SUBJECT: THREE MILE ISLAND, UNIT 1 (TMI UNIT 1)
OPERATING LICENSE NO. DPR-50
DOCKET NO. 50-289
EXIGENT TECHNICAL SPECIFICATION CHANGE REQUEST NO. 309 -
NUCLEAR SERVICES RIVER WATER SYSTEM

TMI Unit 1 Technical Specification Change Request No. 309

Safety Evaluation and No Significant Hazards Consideration

SECONDARY & NUCLEAR
SERVICES RIVER WATER SYSTEMS

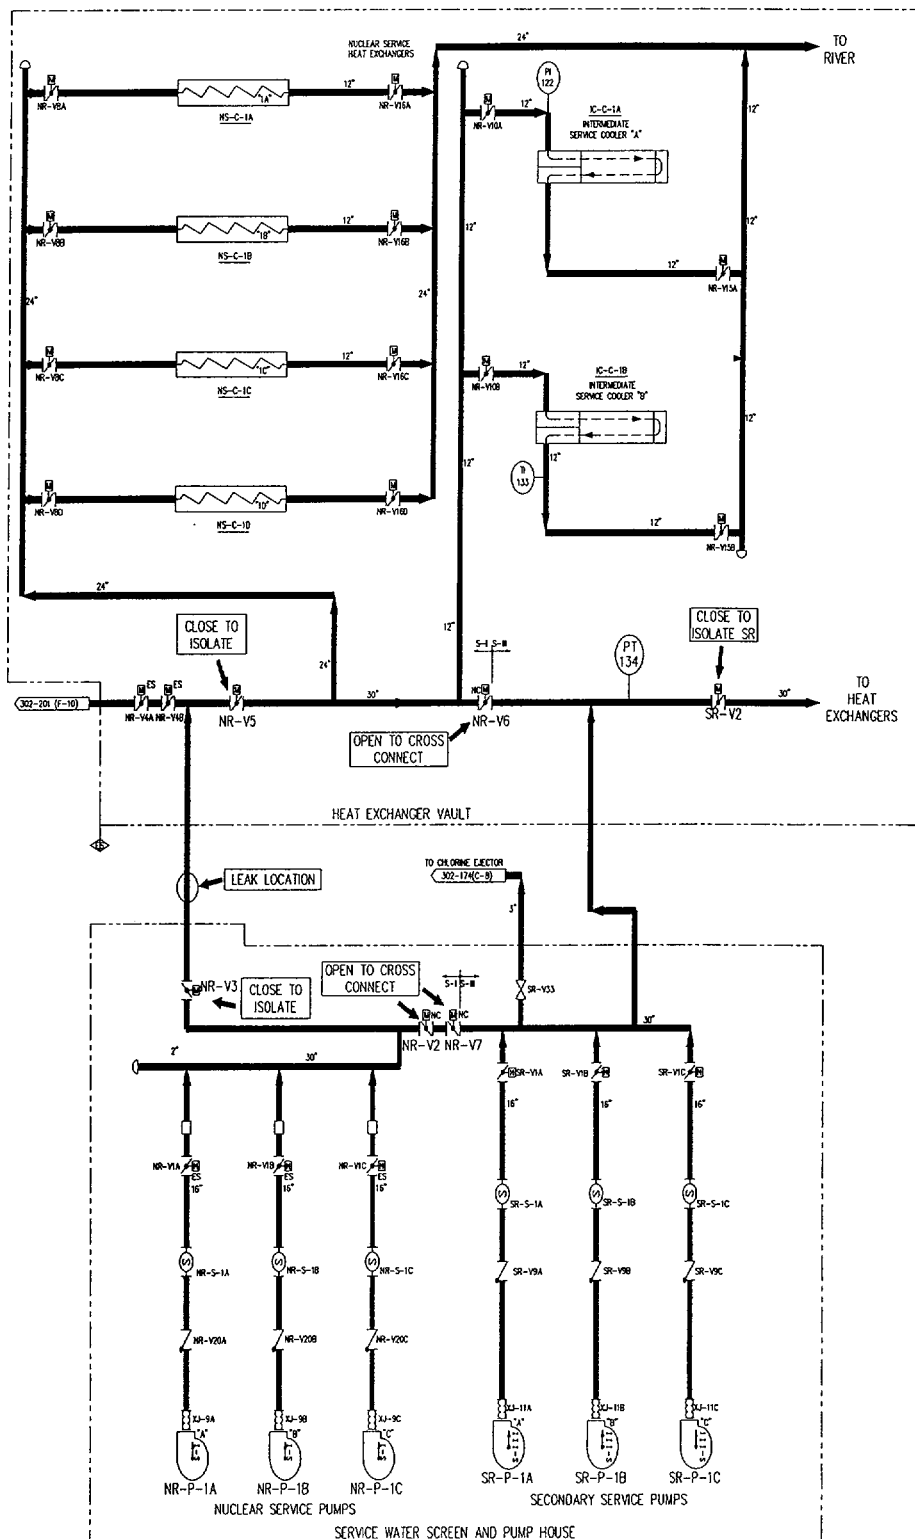
Prior to and during the repair, NR will be cross-connected to SR by opening NR-V-6, NR-V-2, and NR-V-7. The leaking line will be isolated by closing NR-V-3 and NR-V-5. Three NR and three SR pumps will be available. At least two pumps will be operating. Flow will then be provided through the SR underground piping to both SR and NR systems. Two NR pumps, powered from separate 1E buses, will be available to automatically start on Engineered Safeguards (ES) actuation. Attachment 2 shows the key portions of the system.

1. The valves used to isolate the leaking pipe (NR-V-3 and NR-V-5) will be verified acceptably leak tight prior to starting the repair.
2. After the systems are cross connected and the leaking pipe isolated, the breakers will be opened on NR-V-2, 7, 6, 5, and 3 to prevent inadvertent repositioning.
